LINOTYPE IMPROVEMENT INFORMATION SHEET

NO. 251

SPACEBAND LEVER PAWL GUIDE

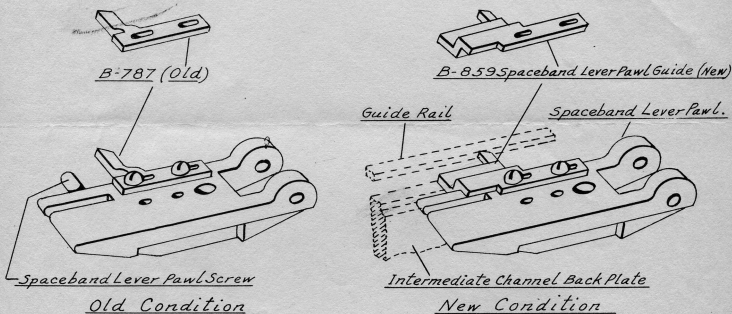
The spaceband lever pawl guide has been redesigned. The new construction provides a wider bearing surface than the old spaceband lever pawl screw and eliminates the tendency of the spaceband lever pawl to wear a depression in the intermediate channel back plate.

Can be applied to outstanding 30 em Models equipped with Spaceband Lever Pawl Guide Rail by substituting B-859.
